INTERNATIONAL STANDARD

AMENDMENT 1

**Semiconductor devices – Discrete devices –
Part 8: Field-effect transistors**

Amendment 1 to IEC 60747-8:2021 has been prepared by subcommittee 47E: Discrete semiconductor devices, of IEC technical committee 47: Semiconductor devices.

Figure 10 – Basic circuit for the testing of peak reverse drain current of MOSFETs

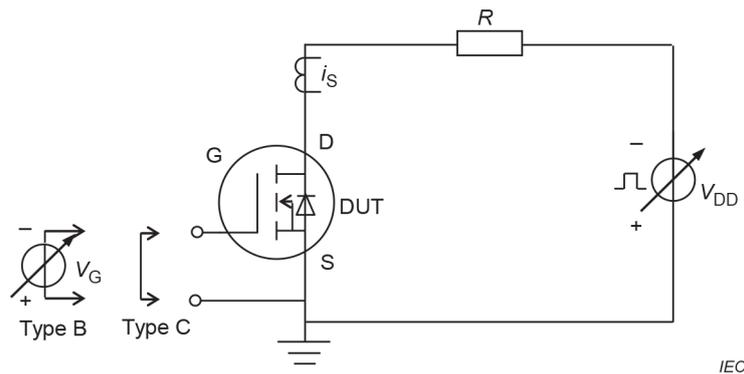
Replace the existing Figure 10 with the following new Figure 10:

6.2.1.7 Peak reverse drain current (I_{DRM})

Replace the existing title of 6.2.1.7 with the following new title:

6.2.1.7 Peak reverse drain current (I_{SM})

Replace, under "Specified conditions", the existing fourth bullet with the following new bulleted point:

- Peak reverse drain current I_{SM}

Figure 34 – Current waveform through MOSFET (Method 1)

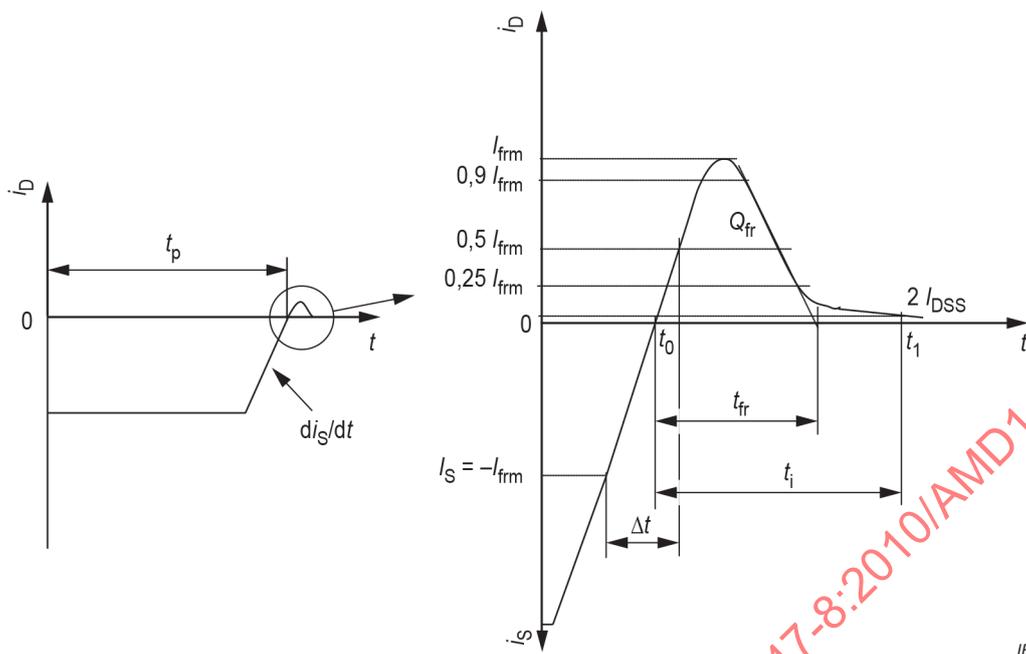
Replace the existing Figure 34 with the following new Figure 34:

6.2.2.2 Reverse-bias safe operation area (RBSOA)

Replace, in 6.2.2.2, the first paragraph of the existing testing procedure with the following:

DUT is turned off at specified I_D and V_{DS} . I_D and V_{DS} are monitored. The DUT has to turn off I_D and withstand $V_{DS} = V_{DS(\text{clamp})}$.

Figure 36 – Current waveform through MOSFET (Method 2)

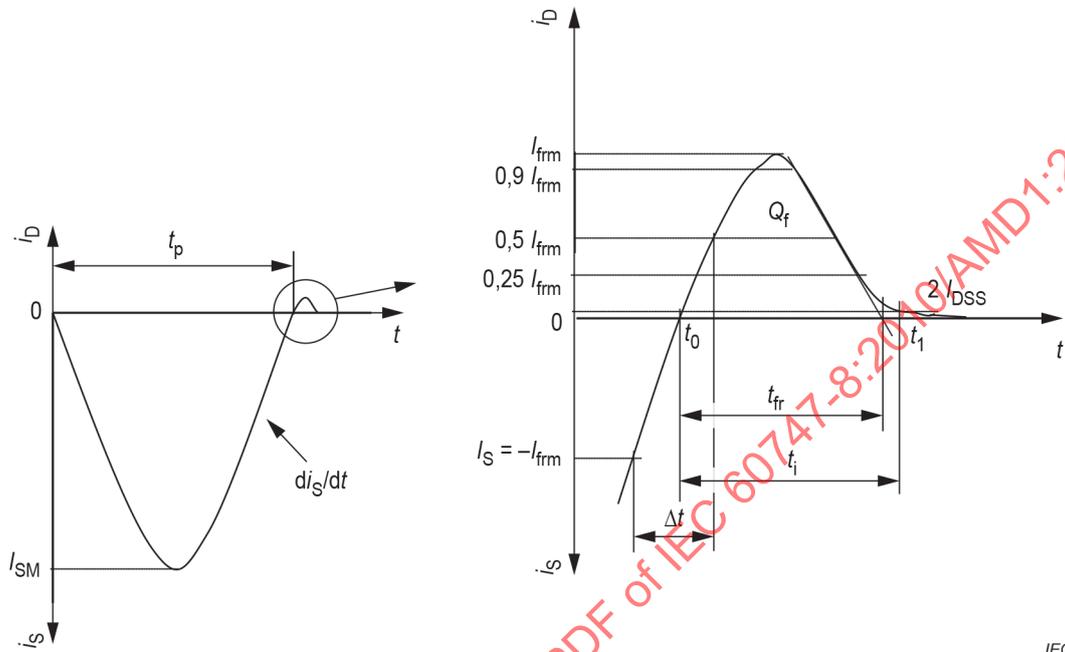
Replace the existing Figure 36 with the following new figure:

Replace, in 6.3.14, Method 2, first paragraph of the measurement procedure, the letter symbols " I_{DRM} " with " I_{SM} ", " di_{DR}/dt " with " di_S/dt " and " I_{FRM} " with " I_{frm} ".

Replace, in 6.3.14, Method 2, the existing second and third bullets under "Specified conditions" with the following new bullets:

- Peak drain reverse current I_{frm}
- Rate of change of drain current di_S/dt

Replace, in 6.3.14, Method 2, the existing note with the following new note:

NOTE The rate of change of drain current is measured at zero crossing current, for example over time Δt , between current values of $I_S = -I_{DM}$ and $I_S = 0,5 I_{DM}$.
